A585 Windy Harbour to Skippool Improvement Scheme

TR010035

7.11 Environmental Statement Changes and Corrections Document

Environmental Statement Changes and Corrections Document

Status	DEADLINE 2 SUBMISSION	Revision	1
Scale	1:2500 A3	Date	MAY 2019
Drawn By	J.NORMAN		
Checked By	K.BURROWS		
Approved By	N.HENDERSON		
PINS No.	TR010035	FIGURE	11.4
Drawing number	HE548643-ARC-EGN-SZ_ZZ_000-DR-LE-30

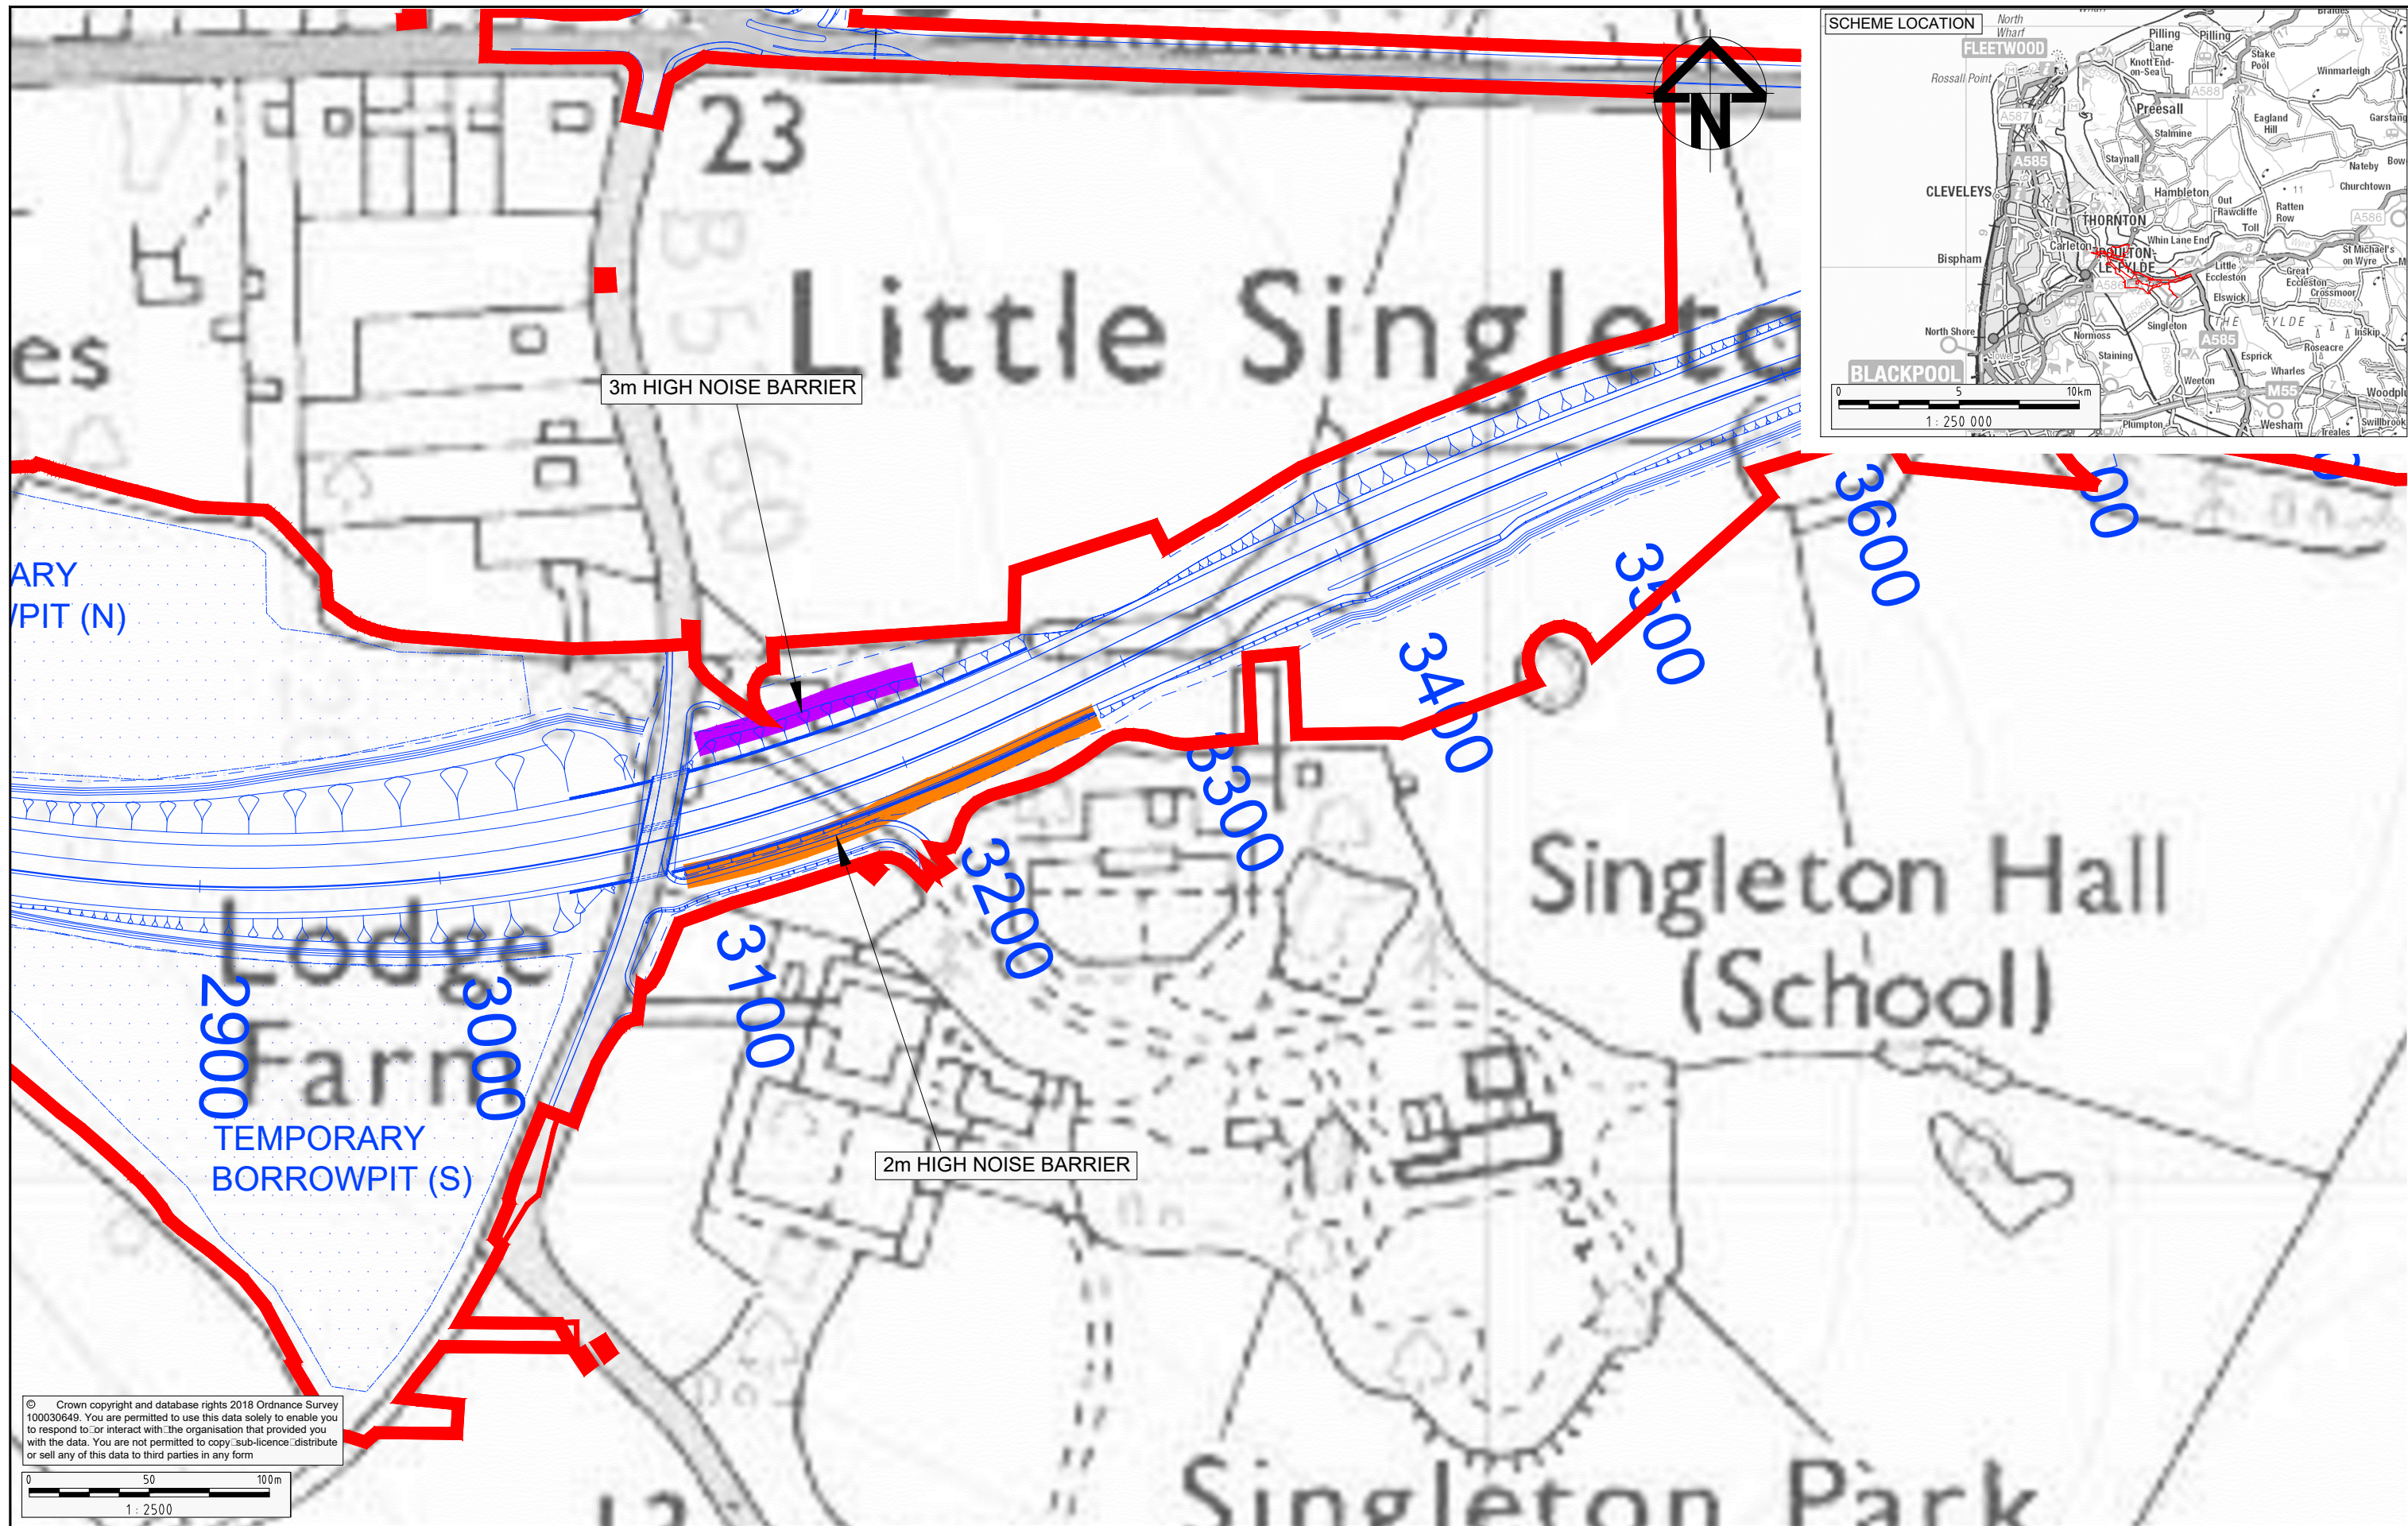
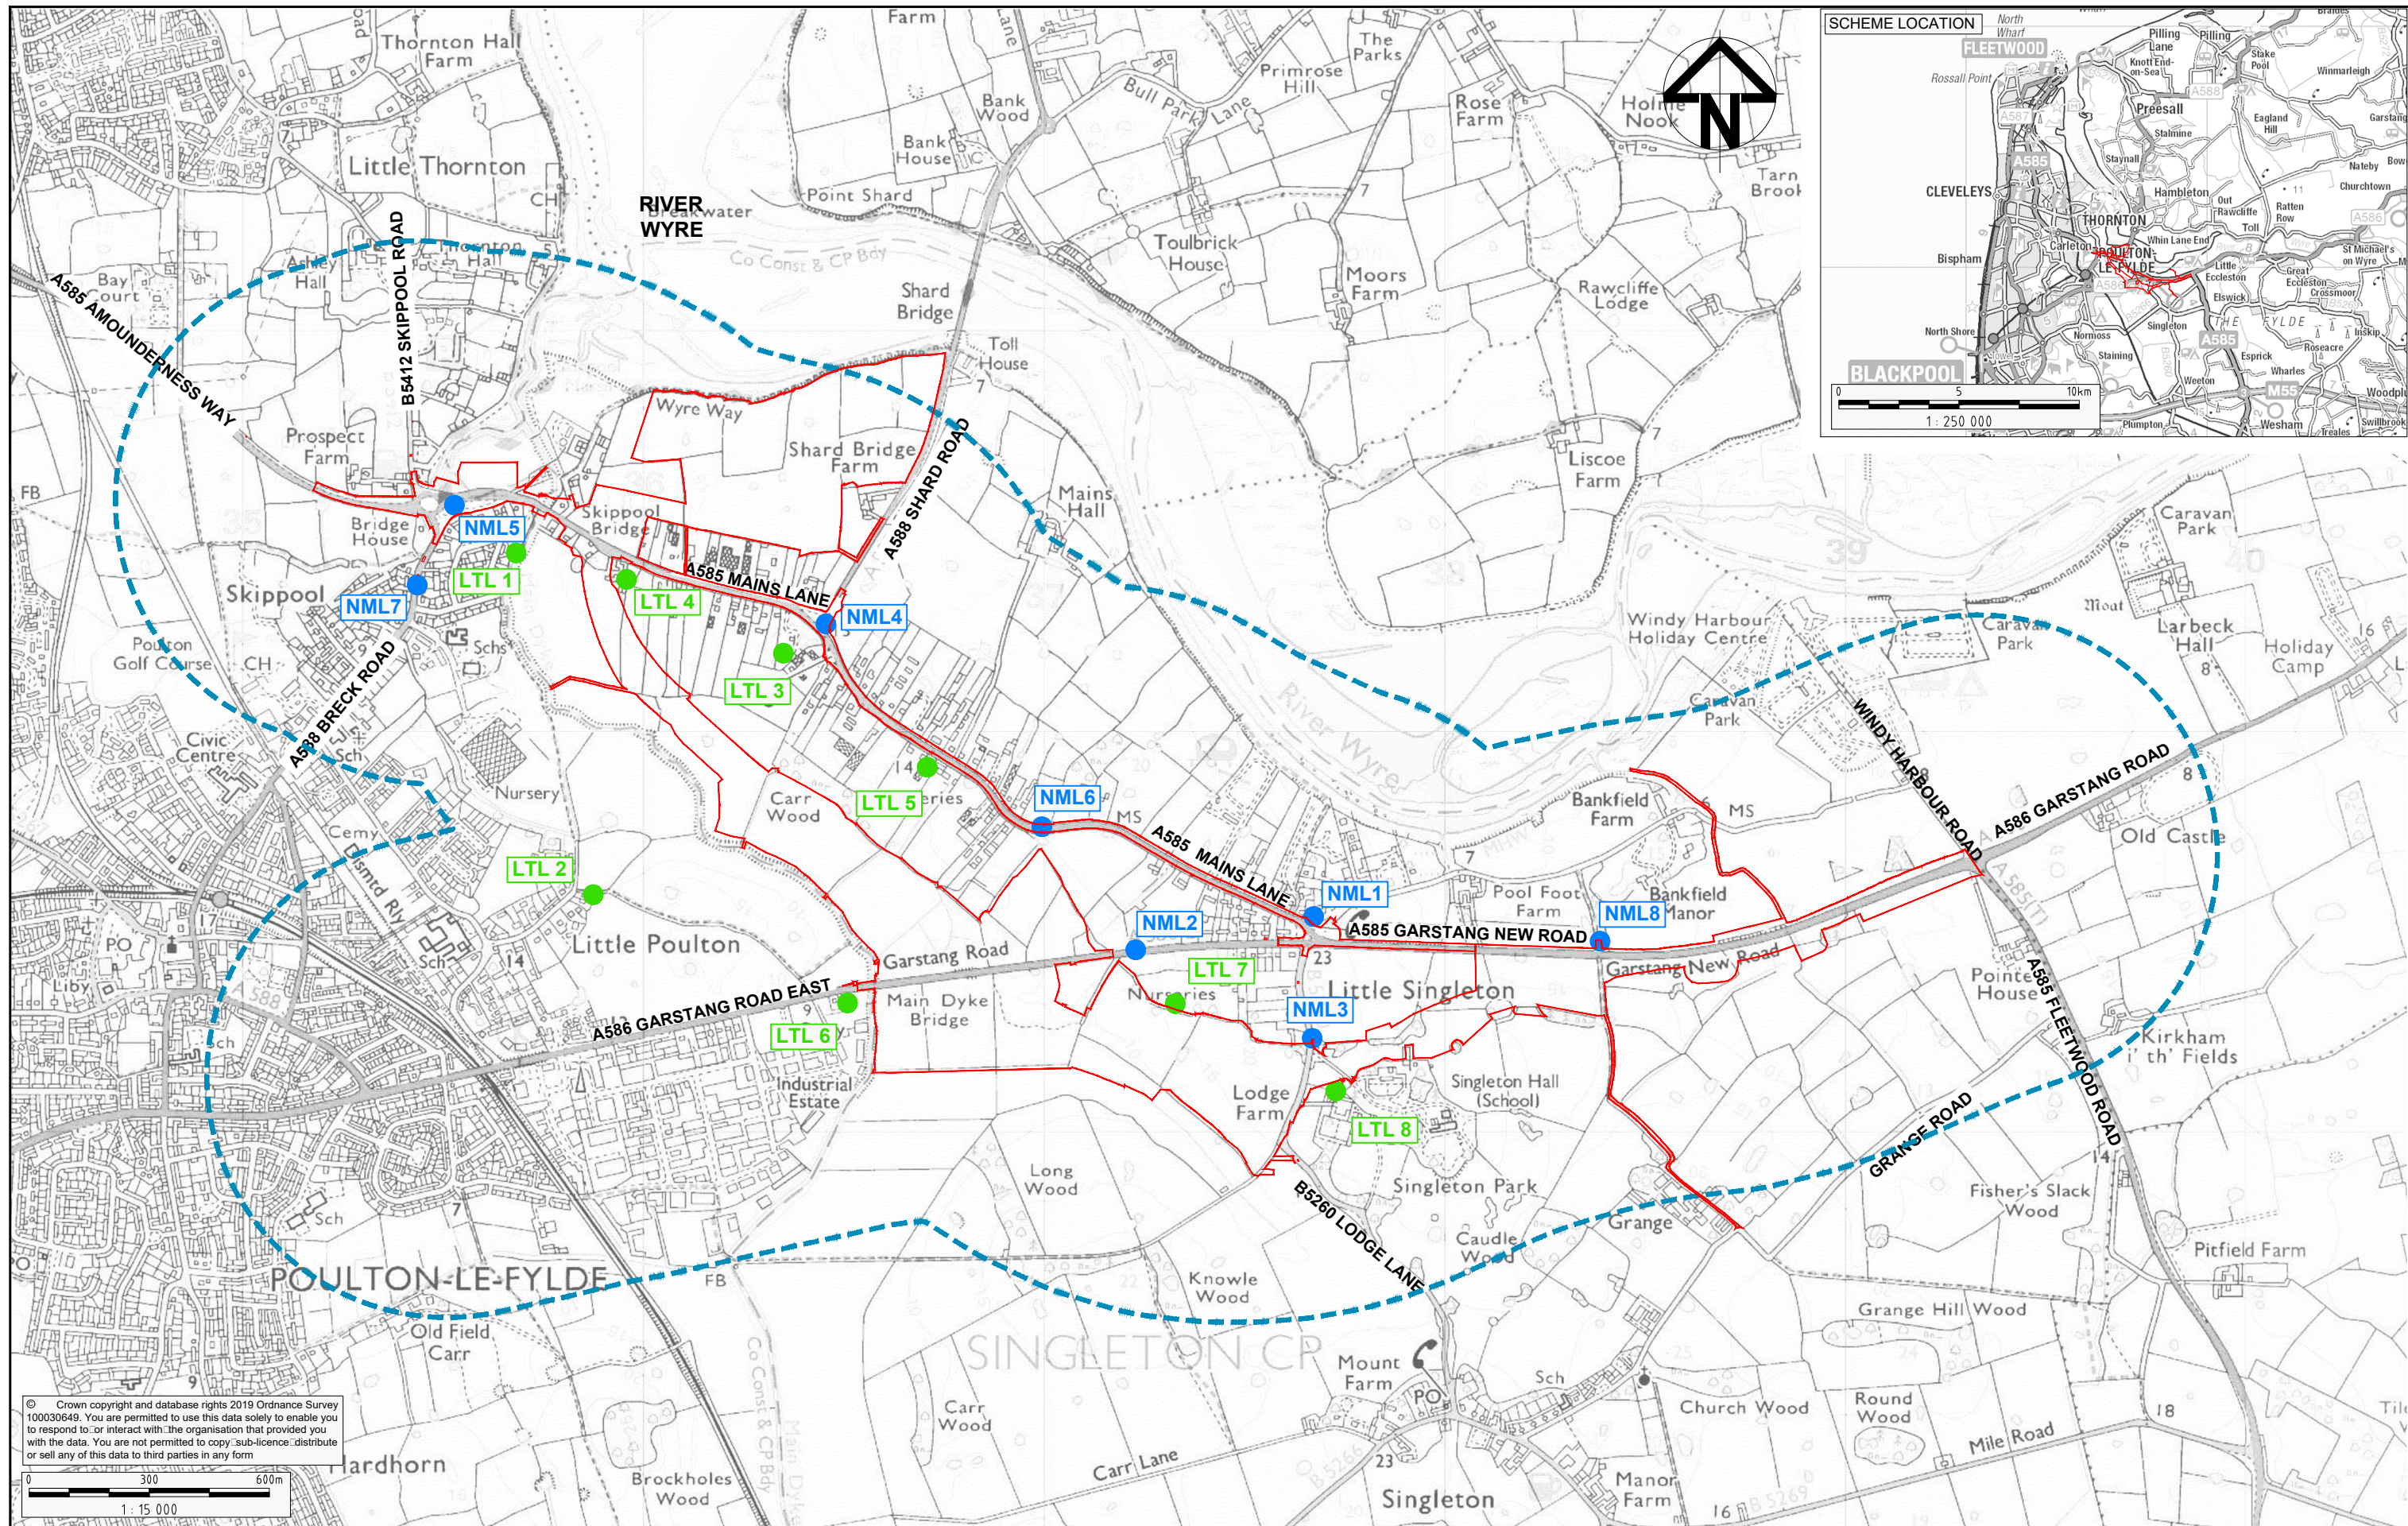
Document Reference Number	Document Name	Amendment Required	Reason
			TR010035/APP/7.10).
6.11	ES Chapter 11: Noise and Vibration	Update to Figure 11.4: Noise and Vibration – Noise Mitigation within the Study Area presented at Appendix D to show heights and locations of earth mounds and acoustic fencing at a larger scale.	Requested by the Inspector within the first round of written questions (document reference TR010035/APP/7.10).

Status	DEADLINE 2 SUBMISSION	Revision	1
Scale	1:15 000 A3	Date	MAY 2019
Drawn By	J.NORMAN		
Checked By	K.BURROWS		
Approved By	N.HENDERSON		
PINS No.	TR010035	FIGURE 11.1	
Drawing number	HE548643-ARC-EGN-SZ_ZZ_000-DR-LE-30

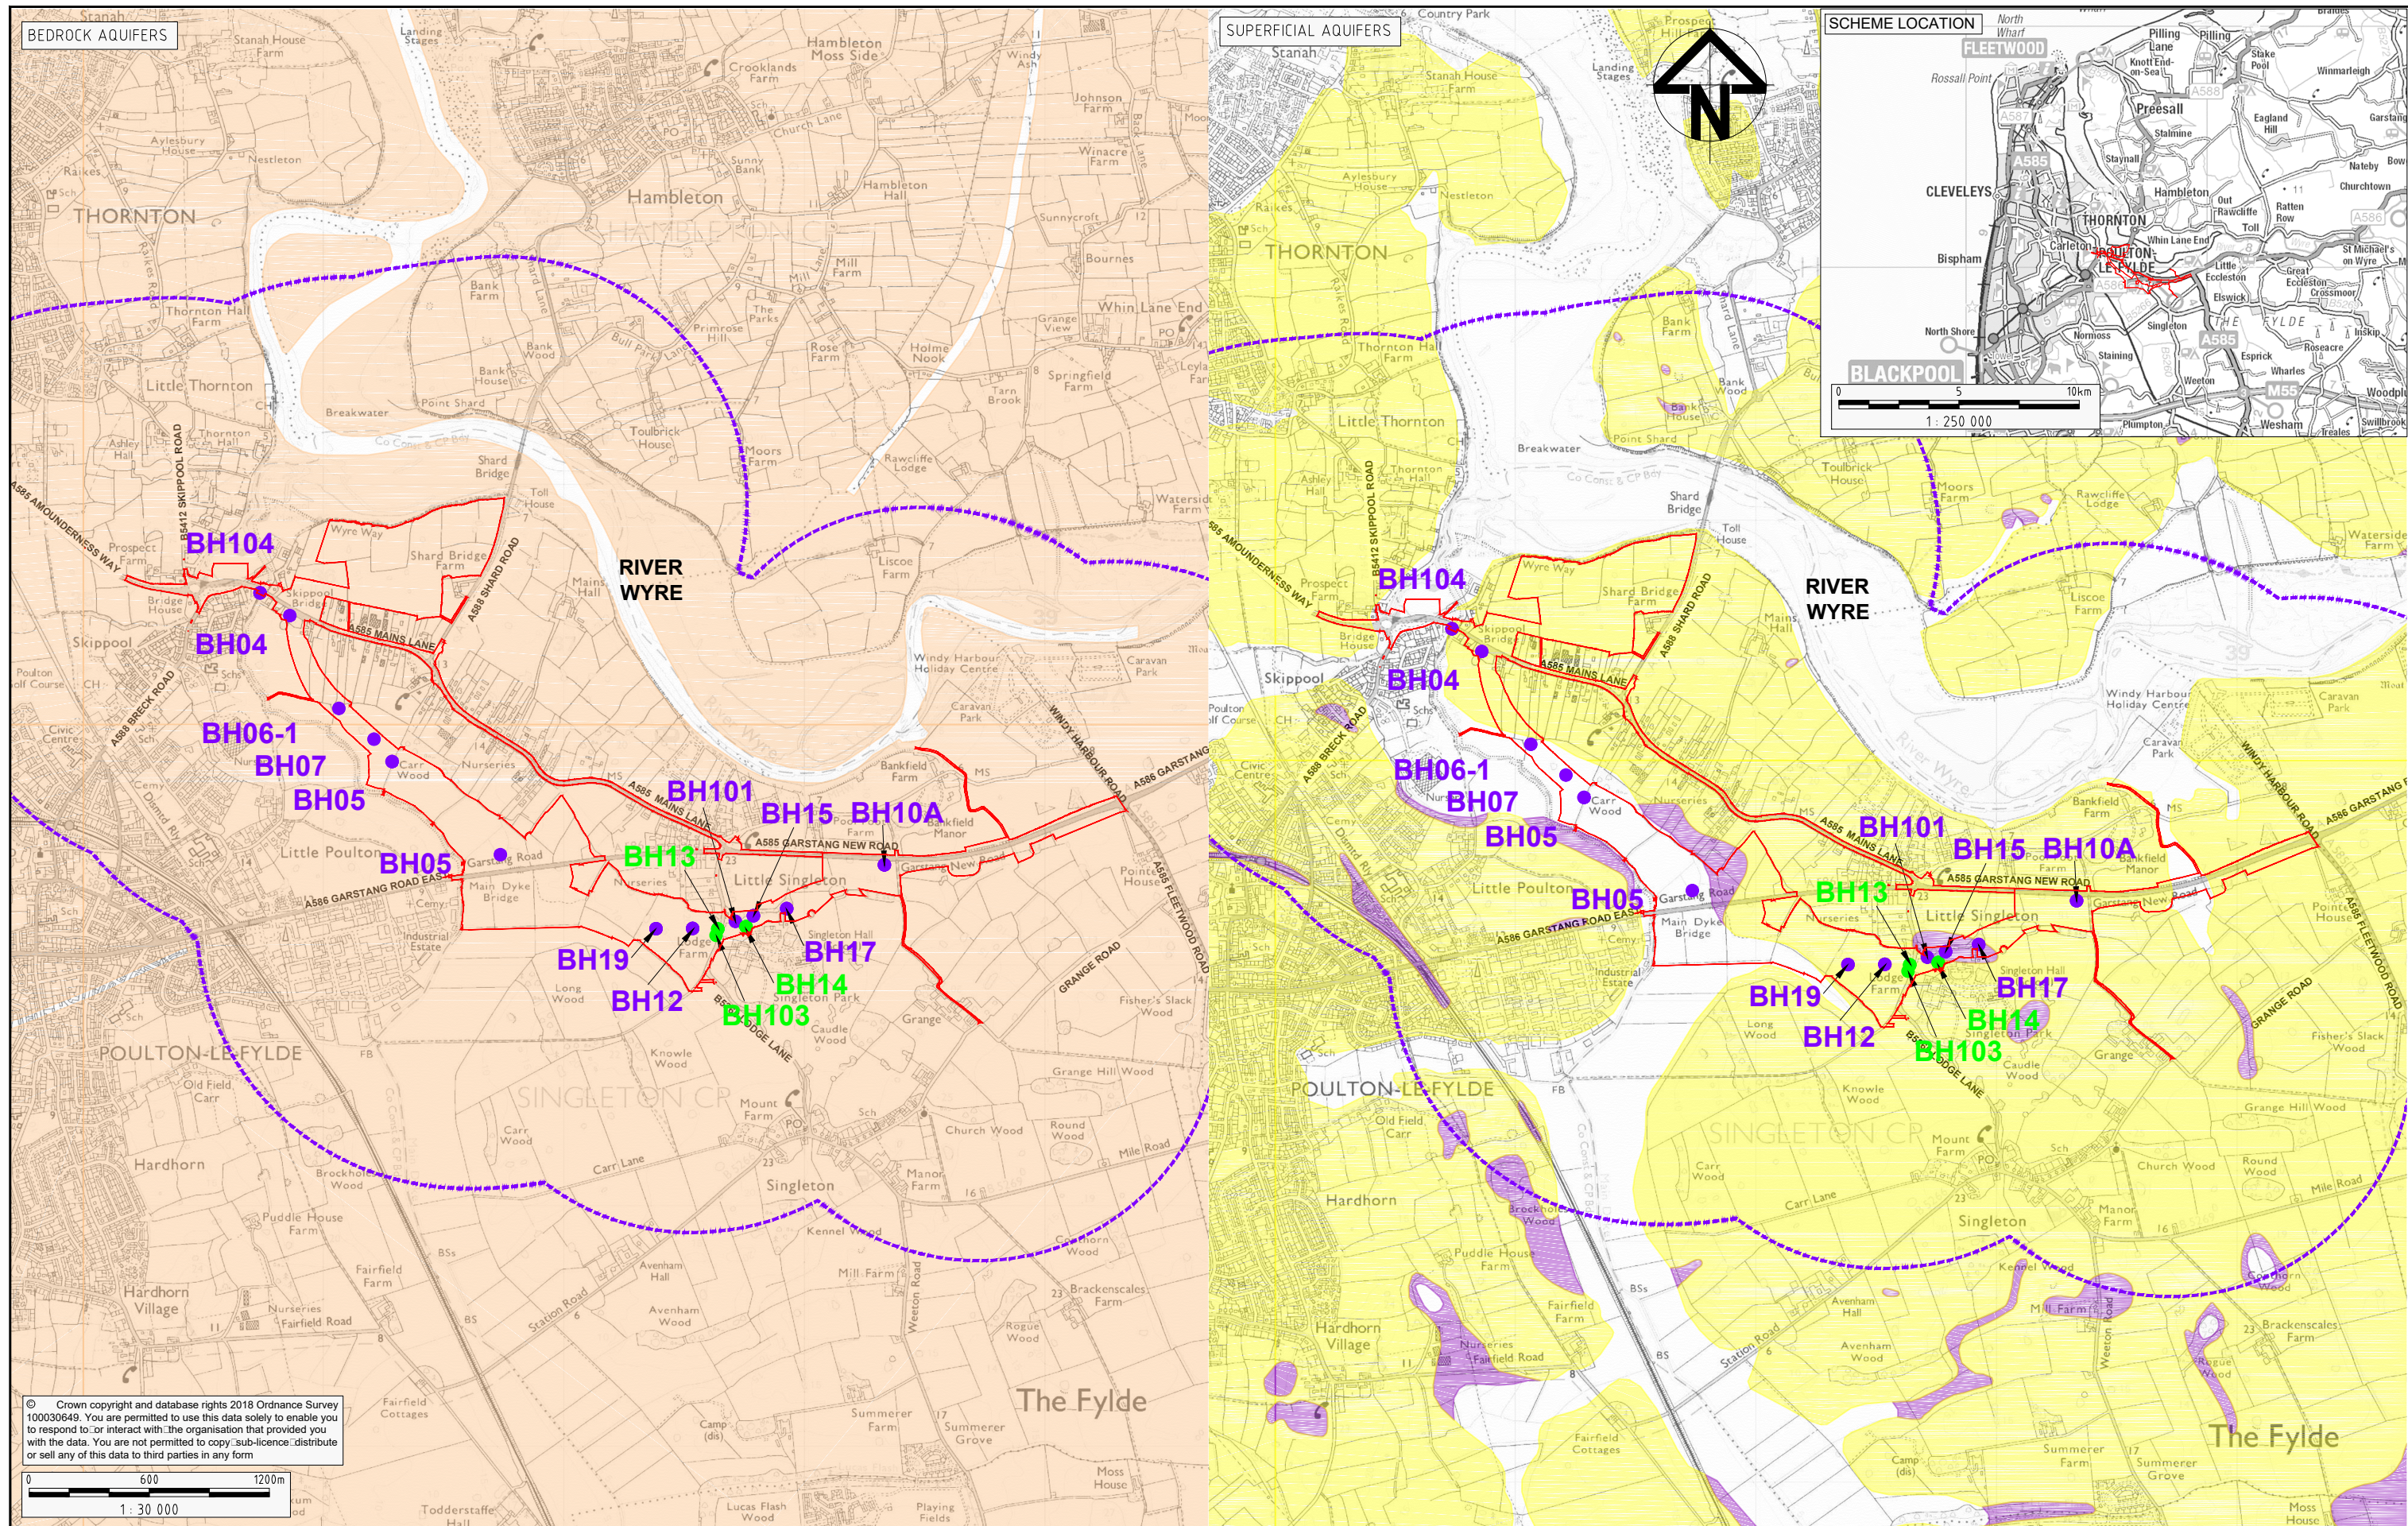
6.11	ES Chapter 11: Noise and Vibration	Update to Figure 11.1: Noise and Vibration – Noise Monitoring within the Study Area presented at Appendix D to show the locations of the eight attended noise surveys.	Requested by the Inspector within the first round of written questions (document reference
